# Safety Evaluation Report

NUREG-0101

## Phipps Bend Nuclear Plant Units 1 & 2

Tennessee Valley Authority

Figure 8 COMPARISON OF HENCH-LEVY AND GEXL WITH 49 ROD ATLAS DATA  
(1.23 CORNER PEAKING, COSINE)

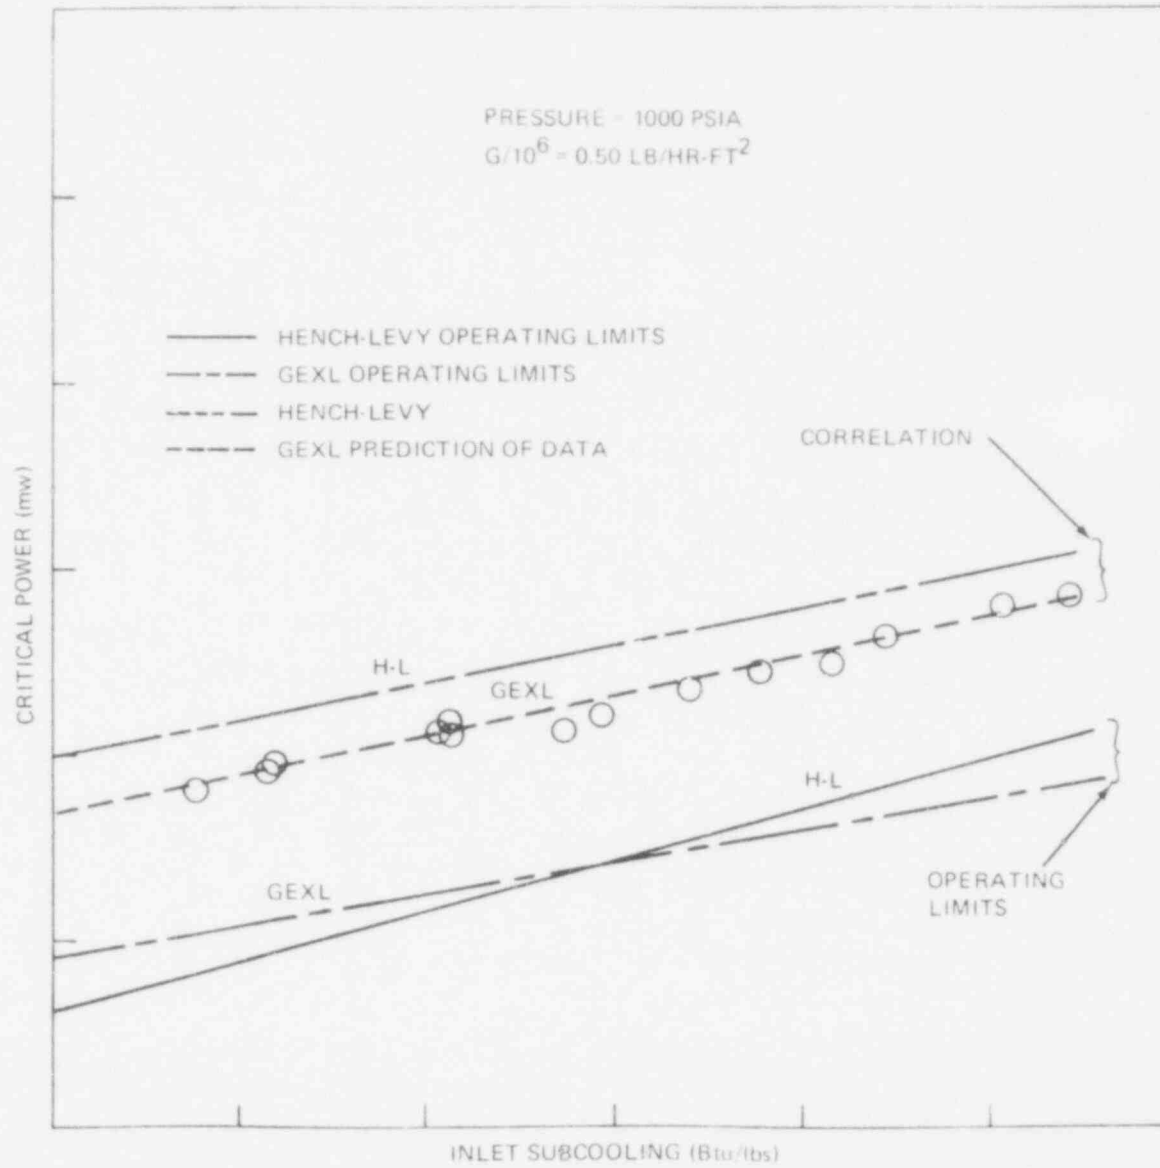
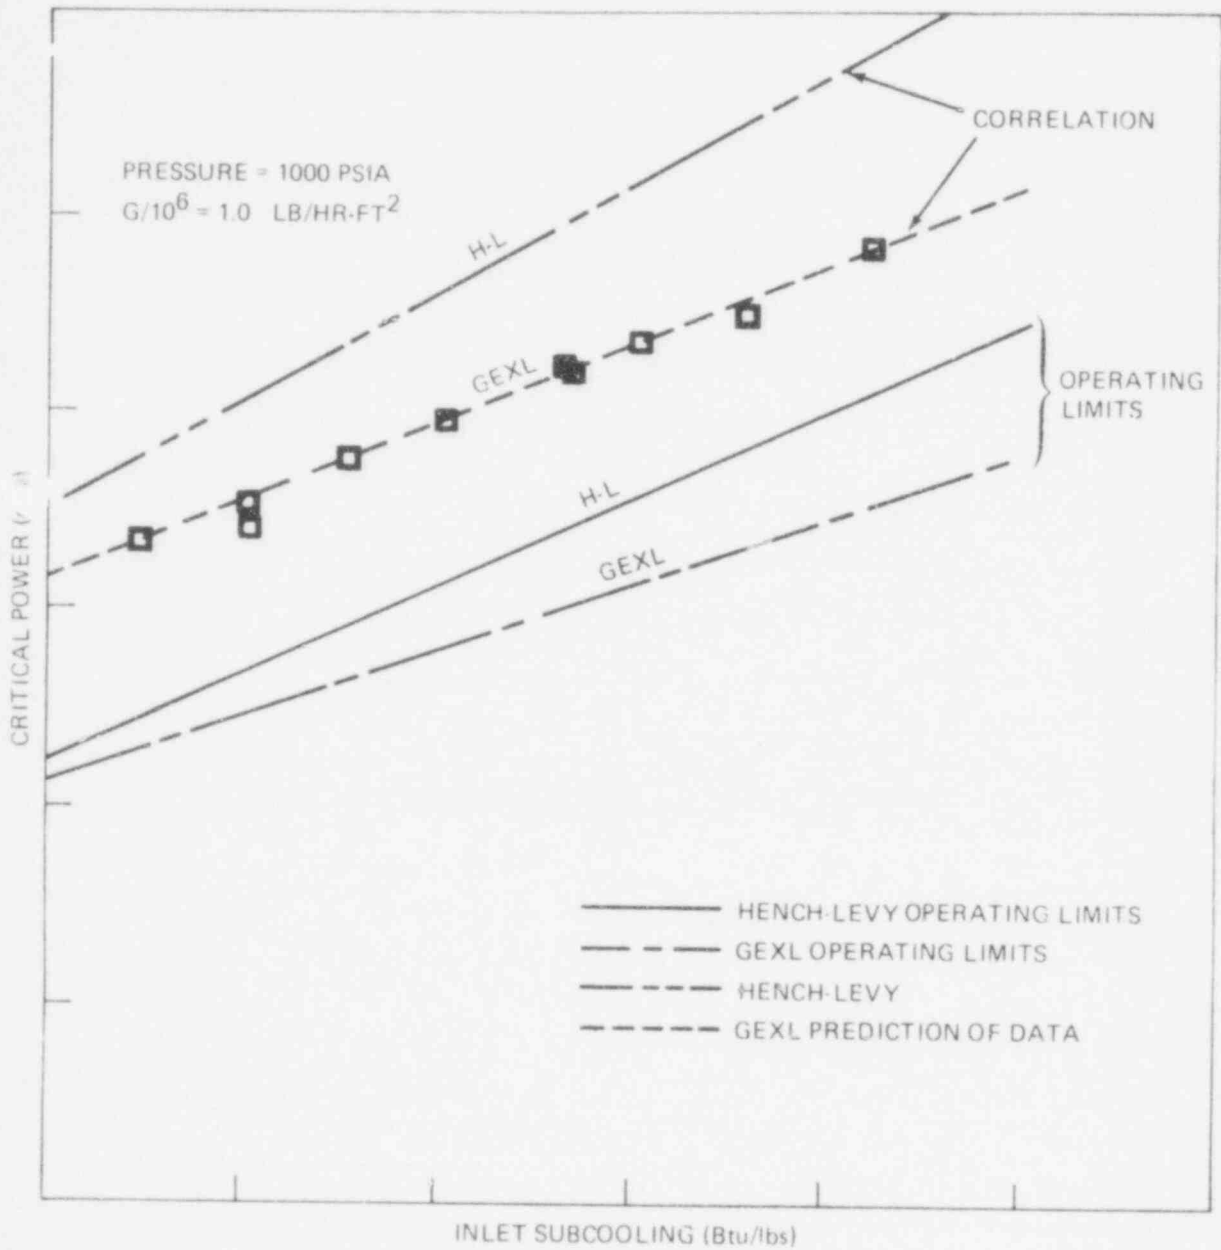
Figures 8 and 9 show critical power, for a 7 x 7 rod bundle, as a function of inlet subcooling, for mass velocities of  $.5 \times 10^6$  and  $1 \times 10^6$  lb/hr sq. ft., respectively. The two upper curves in Figure 8 represent the Hench-Levy correlation and GEXL, respectively, along with experimental data. It is seen that the Hench-Levy correlation predicts about 5 percent greater power than GEXL or the data. The two lower curves represent the operating curves for each of the correlations; Hench-Levy is based on critical heat flux divided by 1.9 whereas GEXL is, in a typical case, based on critical bundle power divided by 1.2.\* Note that, with respect to the operating curves, GEXL permits higher power than Hench-Levy at low inlet subcoolings while the converse holds true at high inlet subcoolings. At a mass velocity of  $1 \times 10^6$  lb/hr sq. ft., as shown in Figure 9, both the Hench-Levy correlation and its operating curve are always higher than the respective GEXL curves.

Figure 10 RESIDUAL VS. AXIAL POWER SHAPE FOR GEXL CORRELATION OF ATLAS DATA

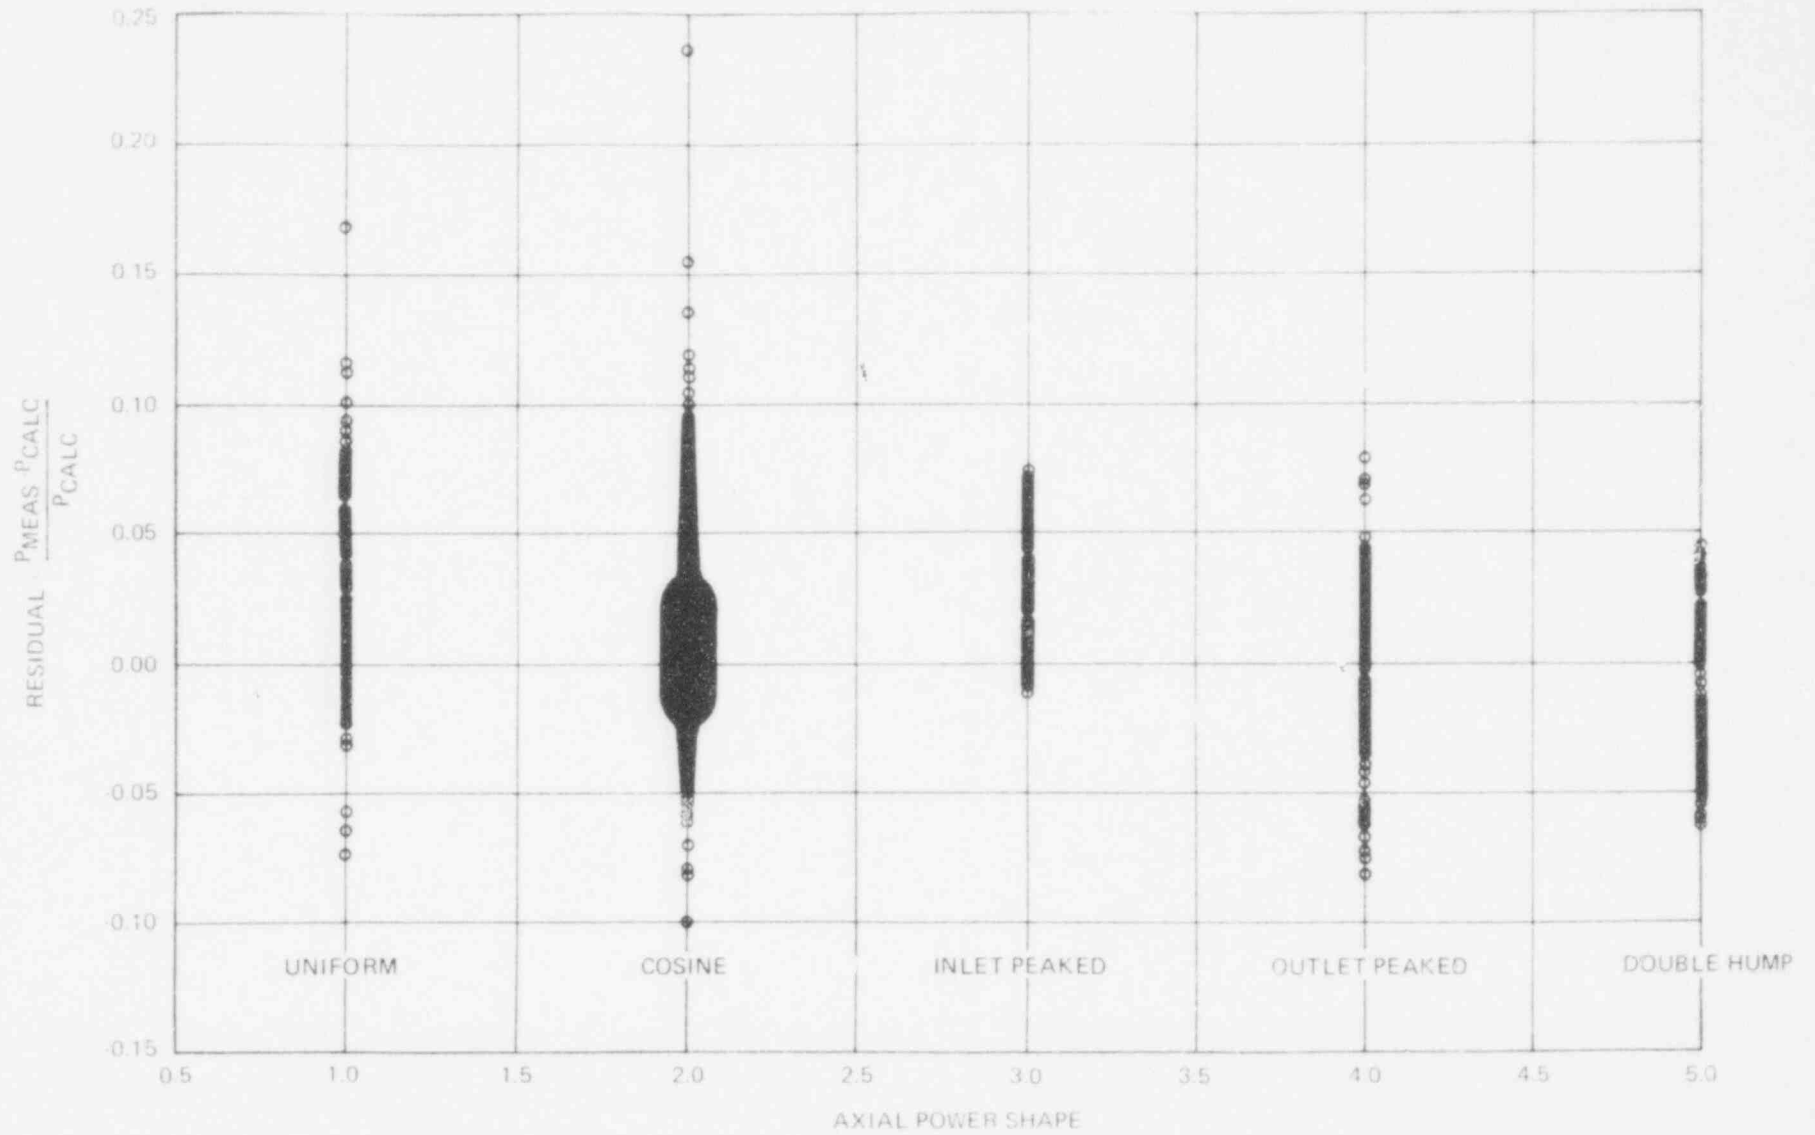
The variation of the ratio of the difference between the measured and calculated power to calculated power with axial flux shape is shown in Figure 10. When compared to the uniform and cosine power shapes which formed the basis for the 7 x 7 and 8 x 8 GEXL correlations, the inlet peak shape is seen to be slightly conservative while the outlet peak and double hump shapes are slightly nonconservative. The same relative positions among the various axial power shapes is shown, in terms of predicted to measured power, on p. 5-5 of Reference 3. However, it should be noted that these comparisons are applicable only to the 7 x 7 lattice as data with inlet peak, outlet peak, and double hump axial shapes have not, as yet, been obtained with the 8 x 8 lattice.
